ADDENDUM NO. 3

1904 / KVCC WHITNEY WING RENOVATIONS

Lewis + Malm Architecture

30JAN2020

5 ADA WELDING BOOTH SECTION
A9 3/4"=1'-0"

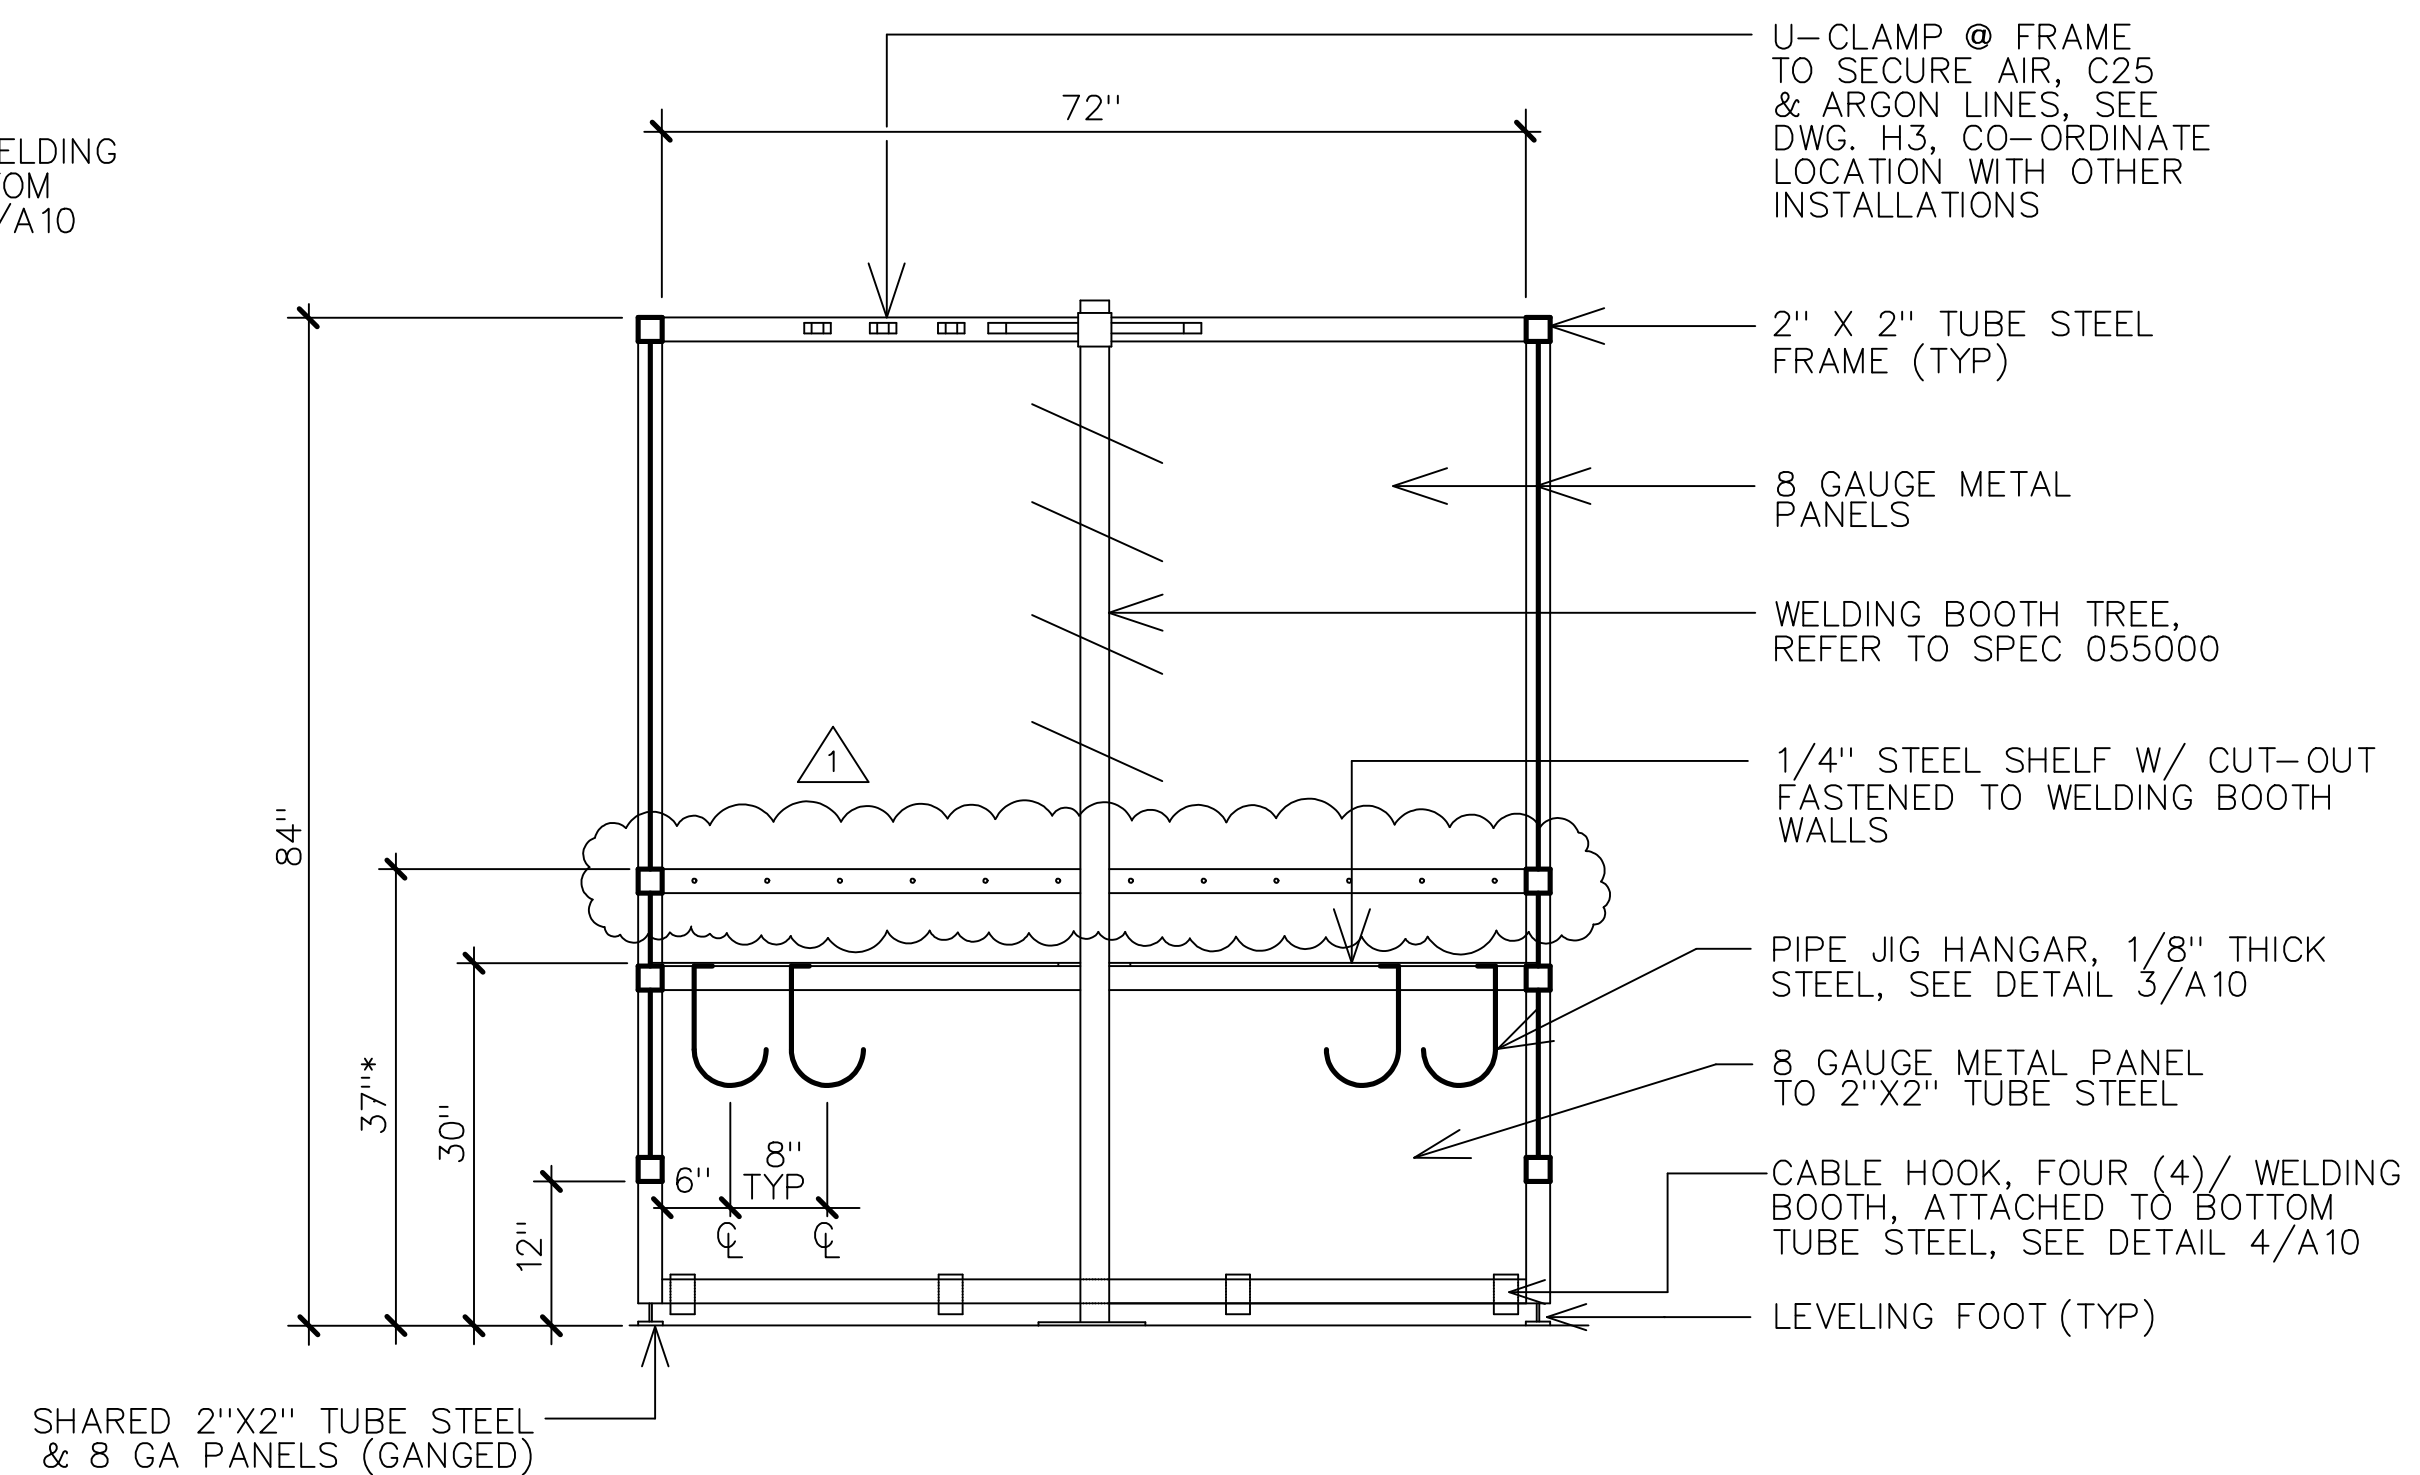
A9 ADD the drawing attached to this Addendum in its entirety (Detail 5/A9 has been revised), The 6'x6' ADA Welding Booths require two horizontal rows of 2x2 steel tube framing on three (3) sides in order to accommodate adjustable height requirements of the 14" deep welding shelves.

5
A10 STEEL SHELF SECTION
6"=1'-0"

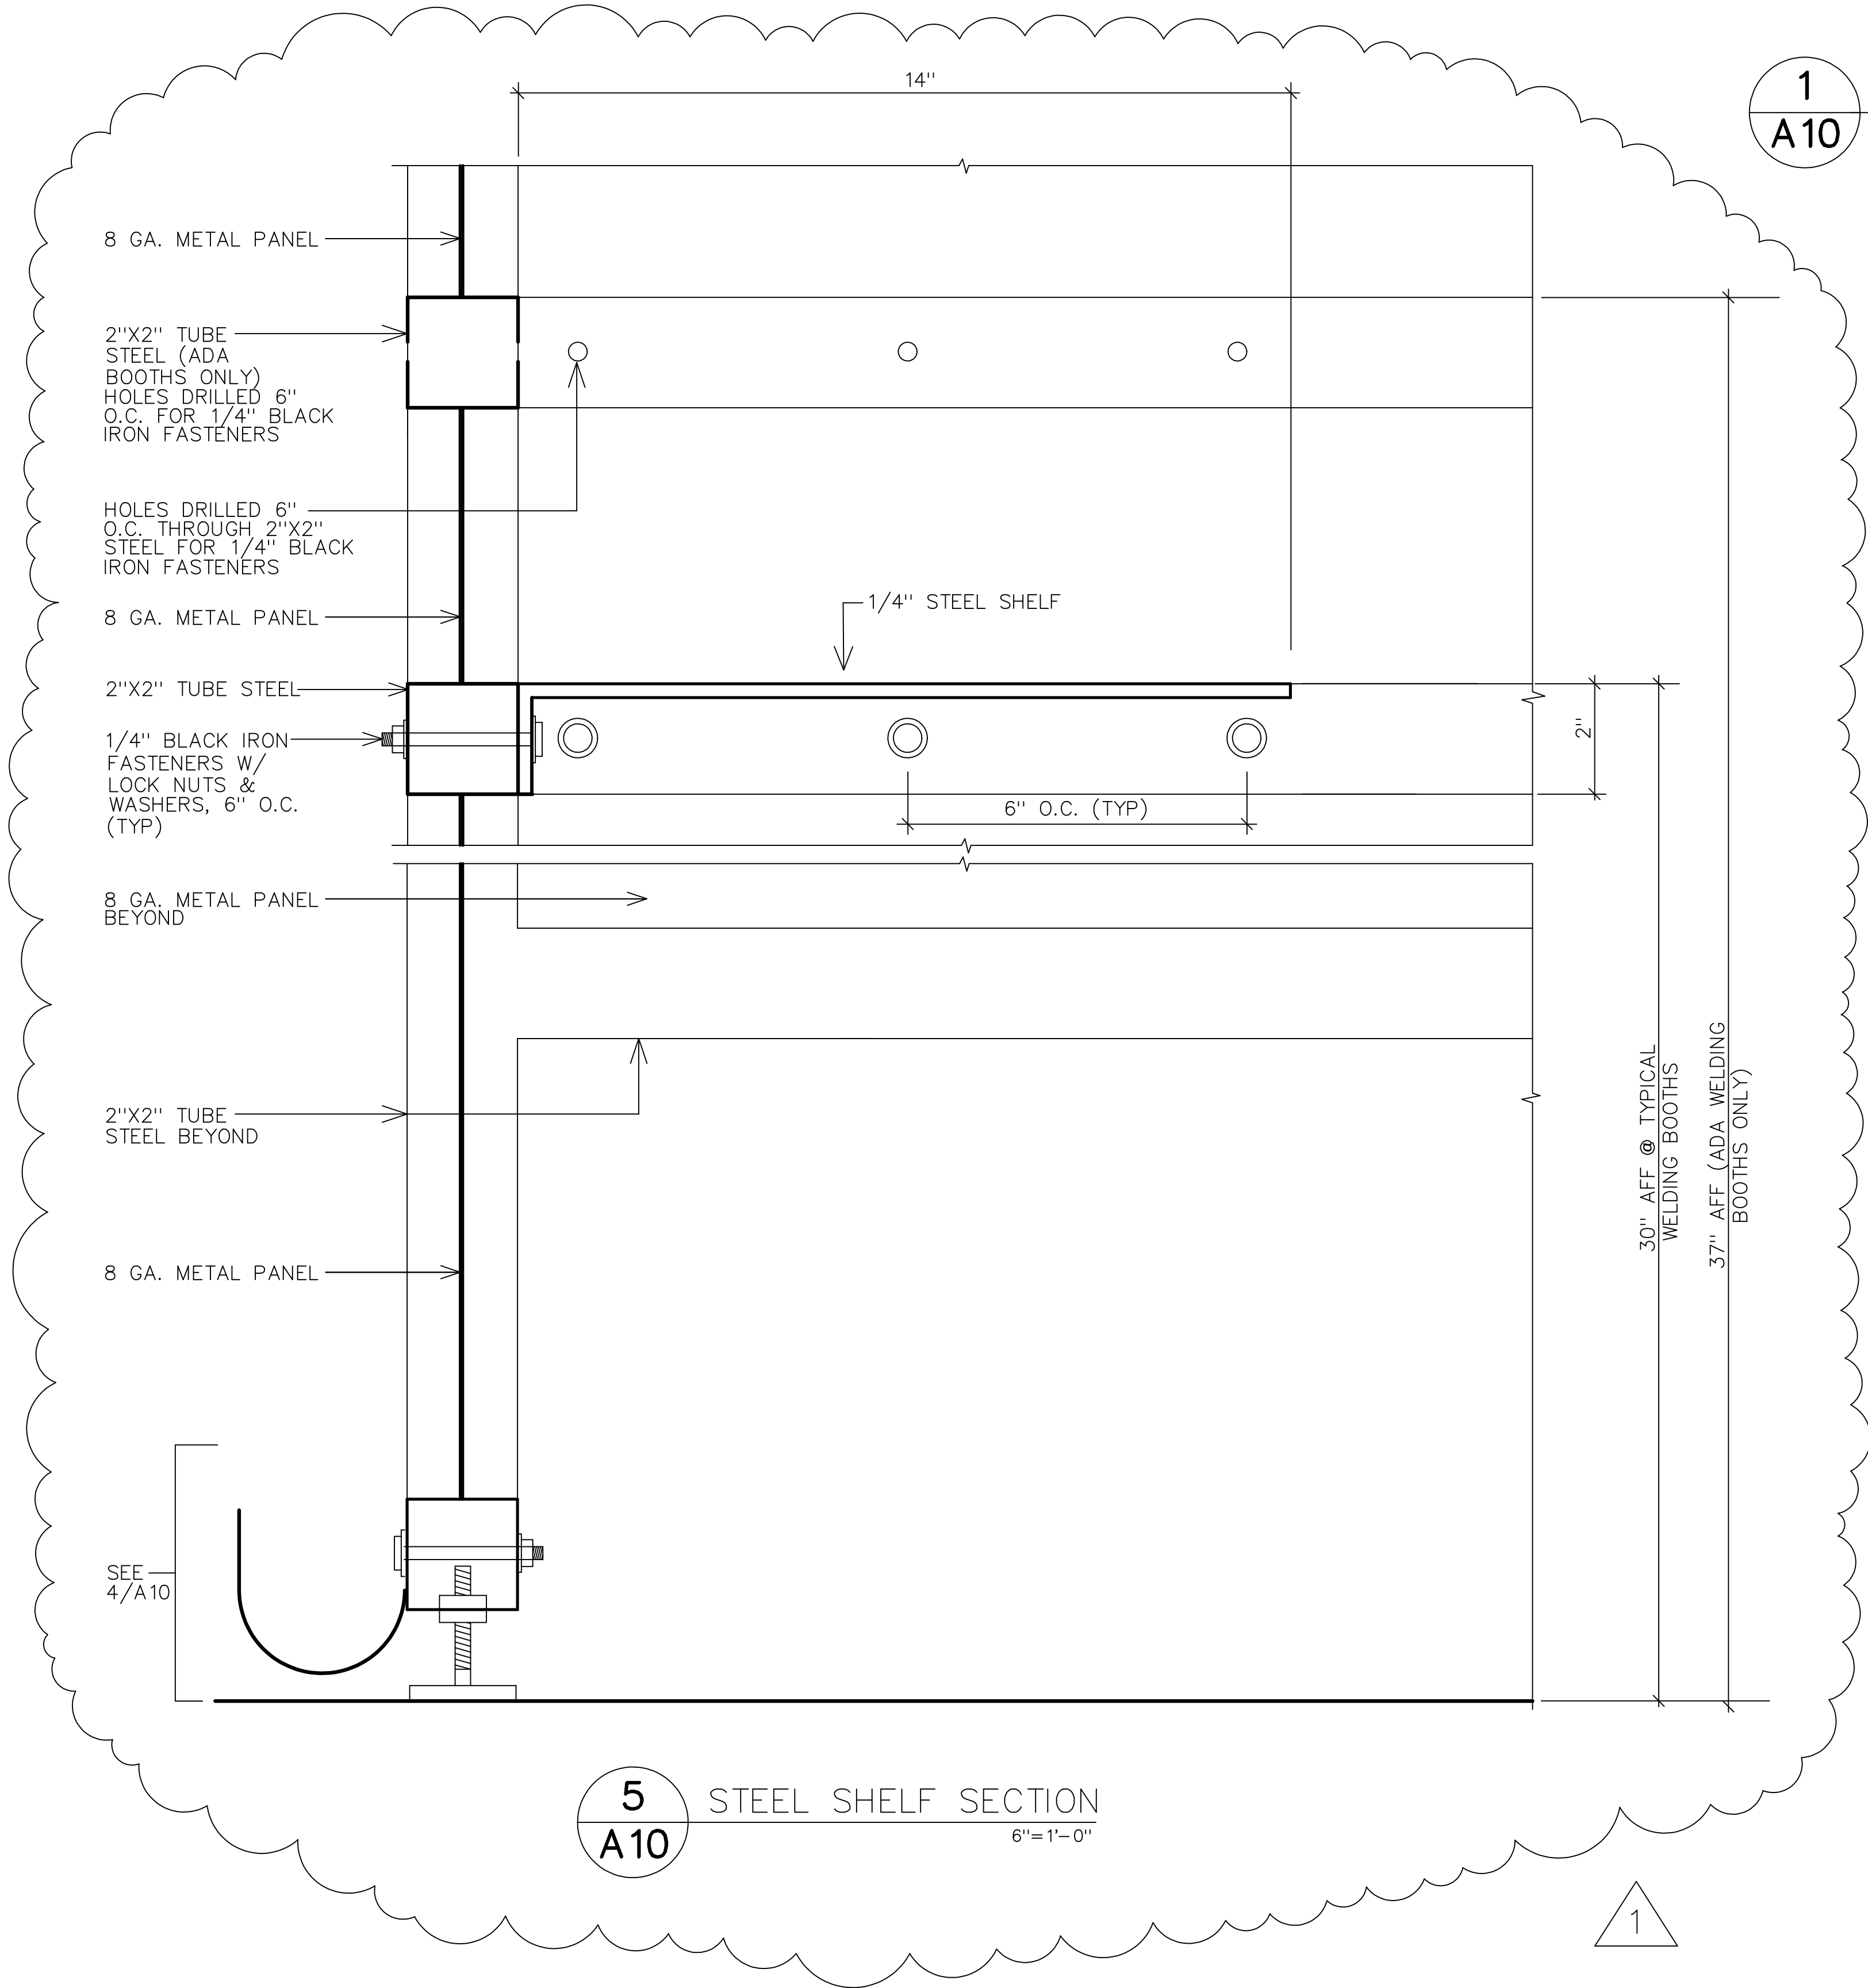
A10 ADD the drawing attached to this Addendum in its entirety (Detail 4/10 has been revised).

MECHANICAL REMOVALS PLAN

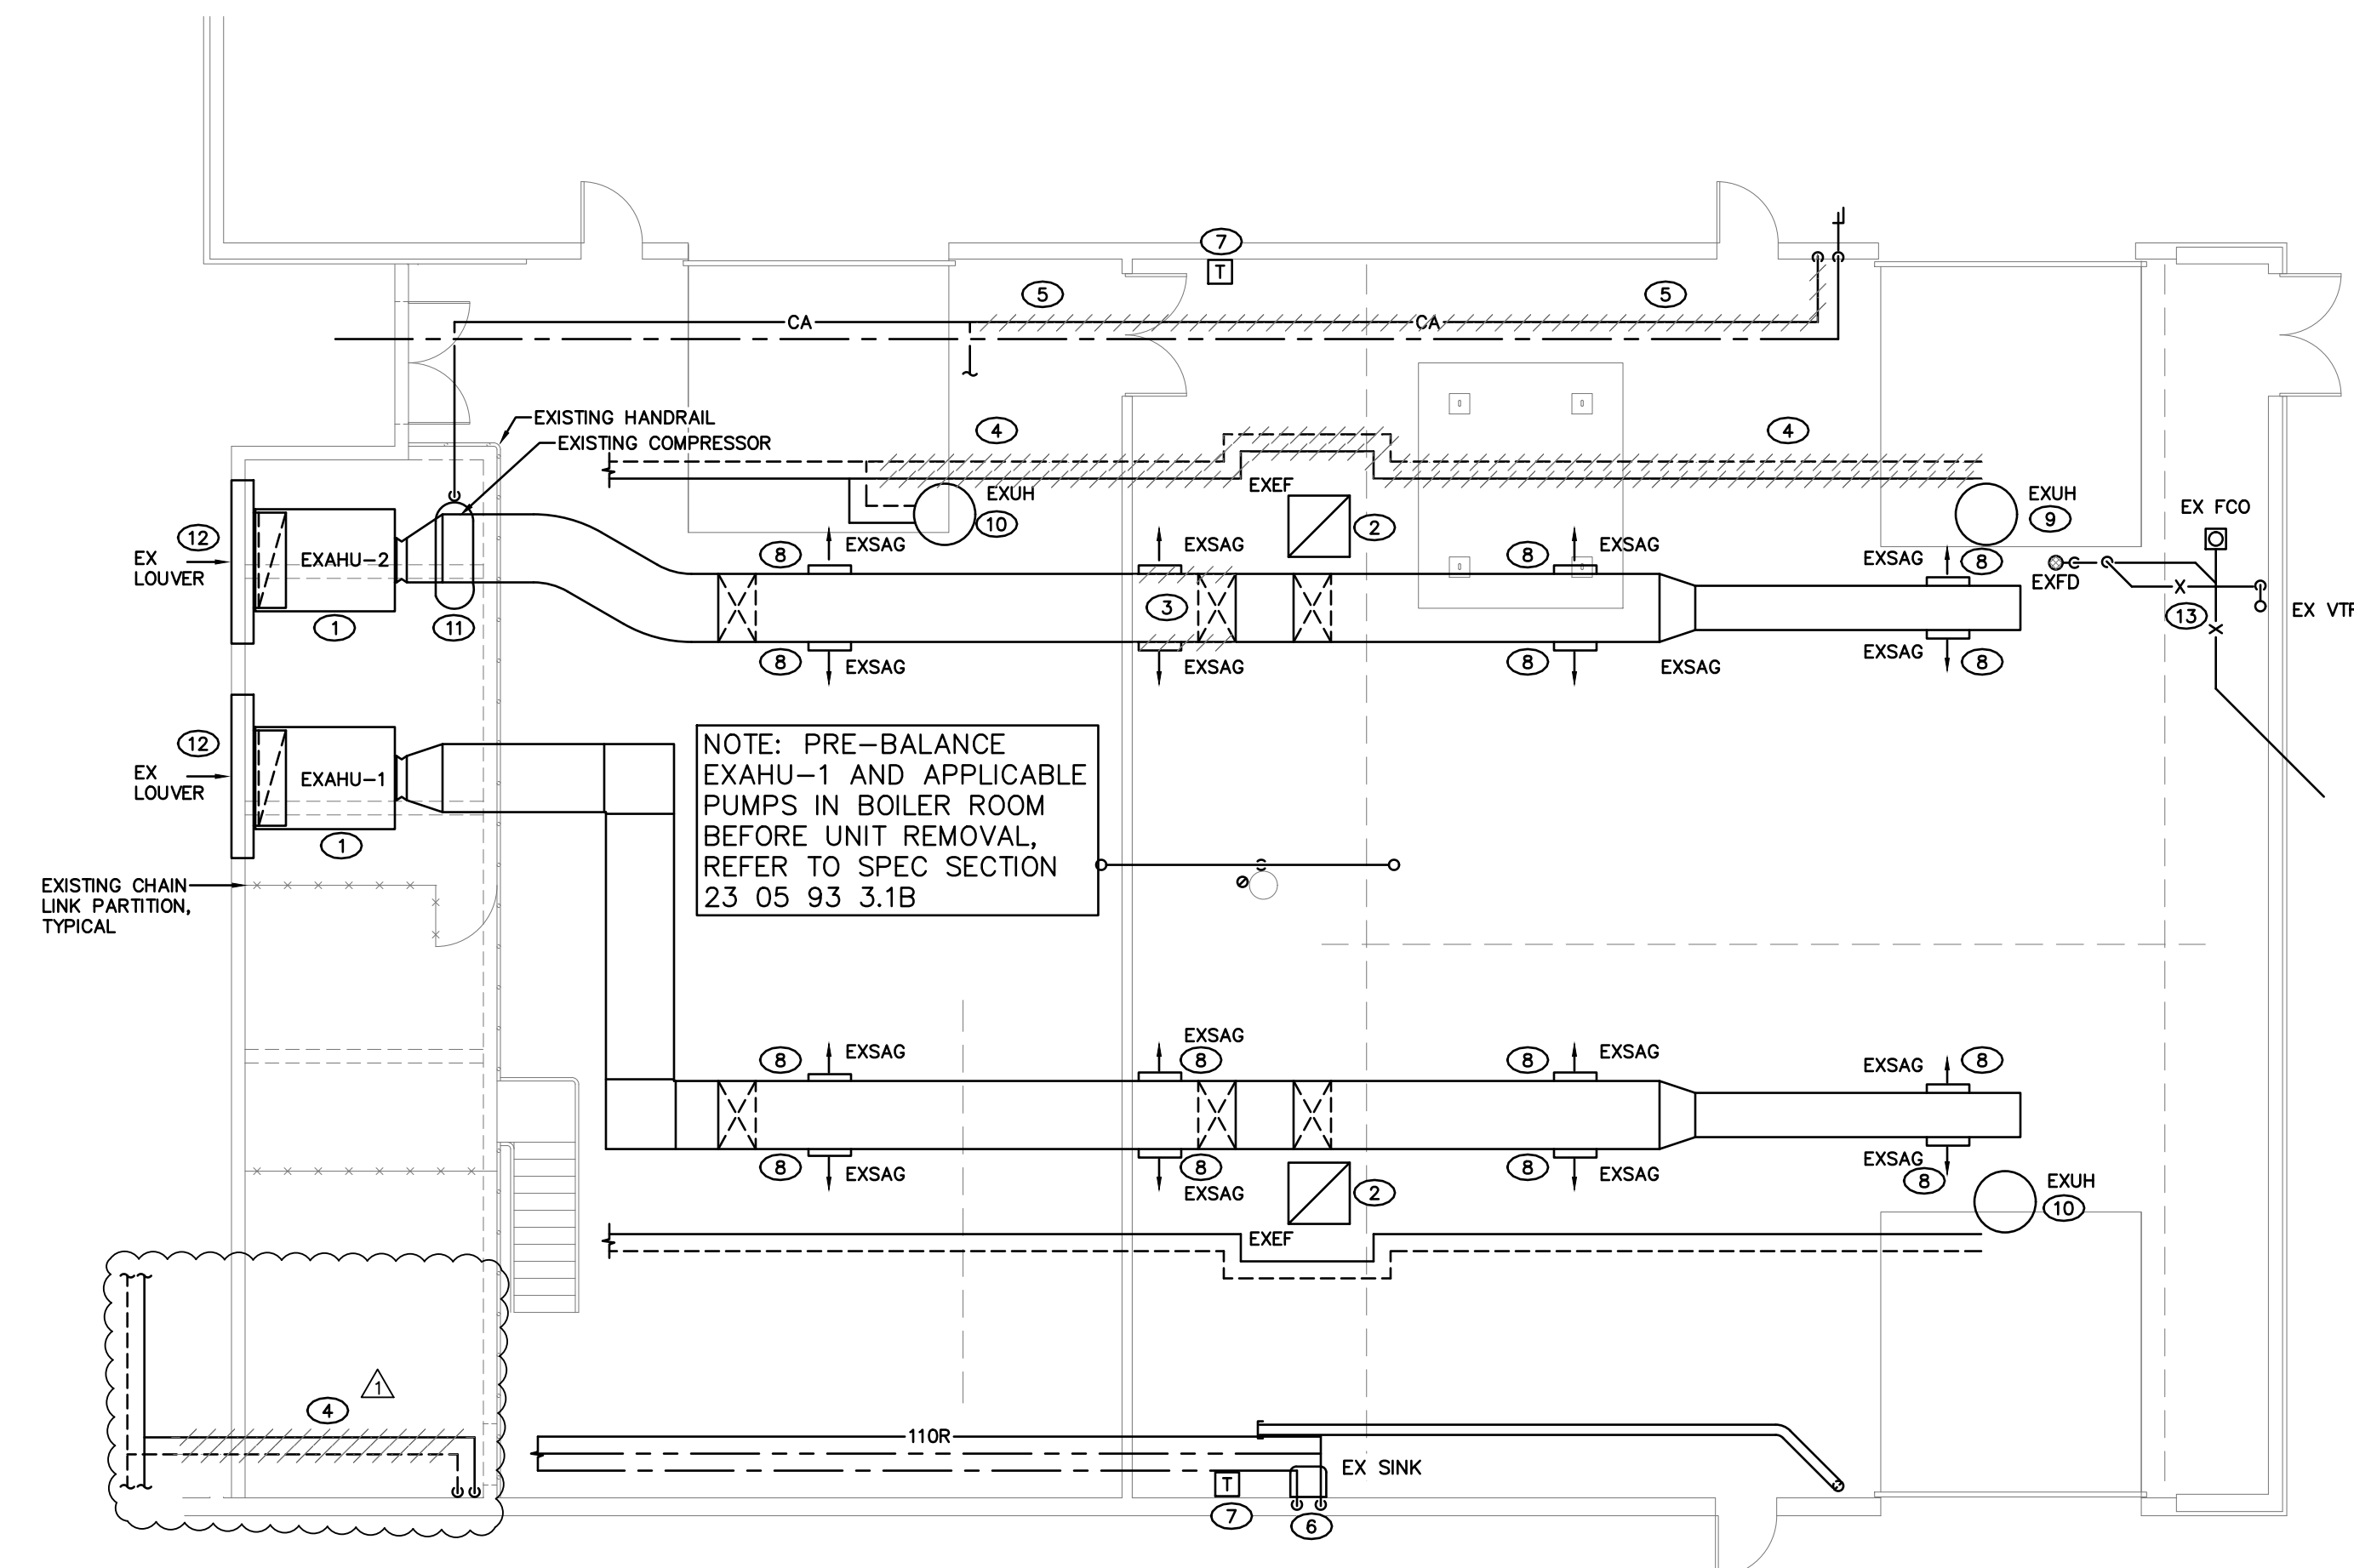
MD-1 ADD the drawing attached to this Addendum in its entirety (shows existing HWS/R piping be rerouted around electrical equipment on the mezzanine).
